HEROES COMMONS REPLAT

SUMMARY

<p><i>Updated: March 6, 2014</i></p>

PROPOSED PLAT

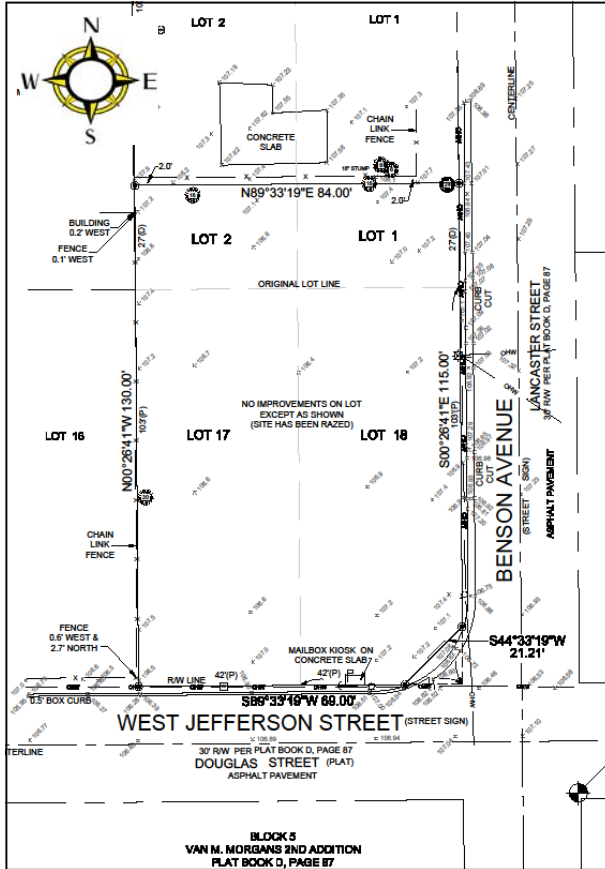
The property is designated R-2B/T/PH (One- to Five-Family Residential, Traditional City Overlay, Parramore Heritage Overlay) and is designated as Residential Medium Intensity. Per Table 2 at right, the replat request does not comply with standards for platting of lands as contained in LDC Chapter 65 Part 3C and needs a Modification of Standards relative to lot width (corner lot only).

Table 2 - Development Standards (R-2B/T/PH)		
Use & Proposed Lot	Lot Size (sq. ft.)	Lot Dimensions (min.)
Single-Family Homes	4,000	40 ft. (w) x 100 ft. (d)
Lot 1	5,200	40 ft. (w) x 130 ft. (d)
Lot 2 (corner lot)*	5,720	44 ft. (w) x 130 ft. (d)
*Corner lots must be 15% (6 ft.) wider than interior lots

When an apartment building occupied the property, the lot was conforming since the 2 lots were bound together by the common use. But when the previous apartment building was demolished, the 1959 “grandfathering” was also lost, requiring the lots to be replatted and brought into conformity with Code. Per LDC Section 58.1152, “when nonconforming residential lots are shown on a plat recorded prior to February 4, 1959, and any portion of two or more lots have been bound together by any action of a property owner to form a conforming building site, the property shall not be split and so as to revert to the original plat except in accordance with the standards provided in this subsection and the procedures provided in Chapter 65, Part 3G (Plat with Modification of Standards).” The property was platted in 1910 as two (2) 42-ft. wide lots, for a total lot width of 84 ft., where a minimum 40 ft. lot width is required for the interior lot and 46 ft. lot width is required for the corner lot.

Based on the information provided in the staff report and the findings noted above, staff recommends approval of the Heroes Commons replat with Modification of Standards, subject to the conditions in this staff report.

PROPOSED SITE PLAN W. FLOORPLANS (PER VAR2013-00084)

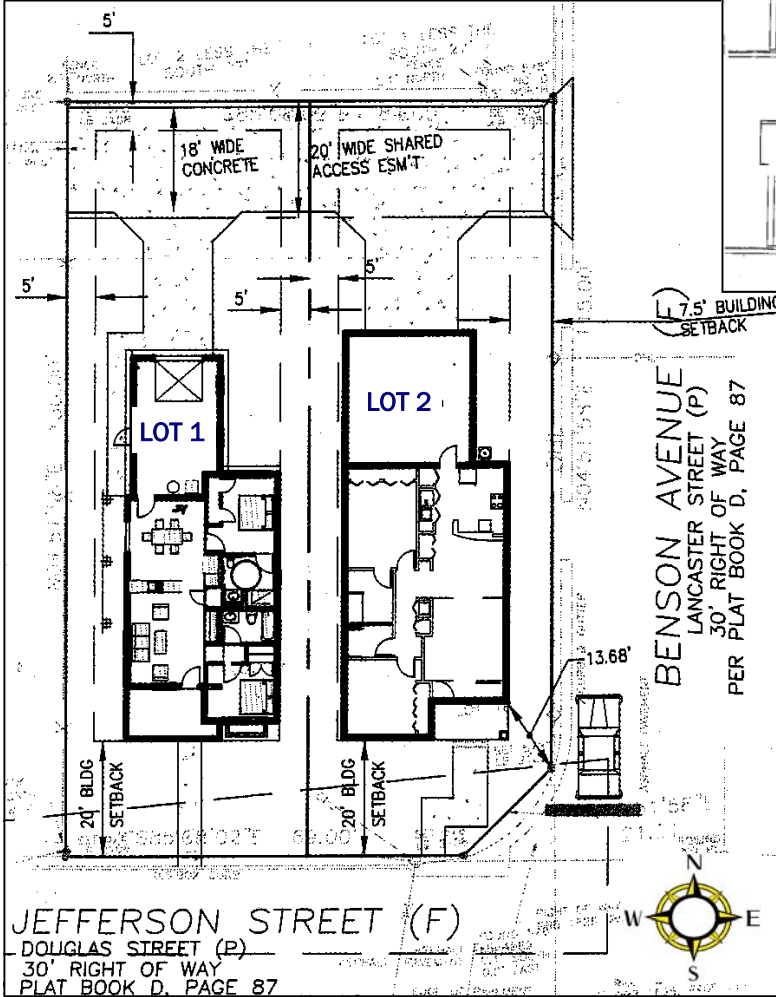
- A. Height. The maximum building height shall be two (2) -stories. *Both homes will be single-story construction.*
- B. Floor Area Ratio (FAR). The maximum floor area ratio shall be 0.50. *FAR for Lot 1 (corner) will be 0.31; 0.21 for Lot 2.*

- C. Location of Required Parking. All required parking spaces and garage door elevations shall be set back a minimum of five (5) feet from the principle facade of the principle building. For each lot, the combined width of all garage door(s) facing a street shall not exceed fifty percent (50%) of the combined width of all building elevations facing the same street. Garage accessory structures in the rear half of the lot shall not be included in this calculation, except when the garage accessory structure is located on a corner lot and faces a side street. When a garage accessory structure is located on a corner lot and faces a side street, the garage accessory structure shall be set back a minimum of twenty (20) feet from the street side property line and the combined width of all garage door(s) facing a street shall not exceed thirty-five percent (35%) of the combined width of all building elevations facing a street, including the garage accessory structure. *Both homes will have rear entry attached garages.*

1. Development shall be per conditions of VAR2013-00084.
2. Except as provided herein, the proposed plat is subject to all codes and ordinances of the State of Florida, City of Orlando, and all other applicable state regulatory agencies. Any applicable state or federal permits must also be obtained before commencing development.
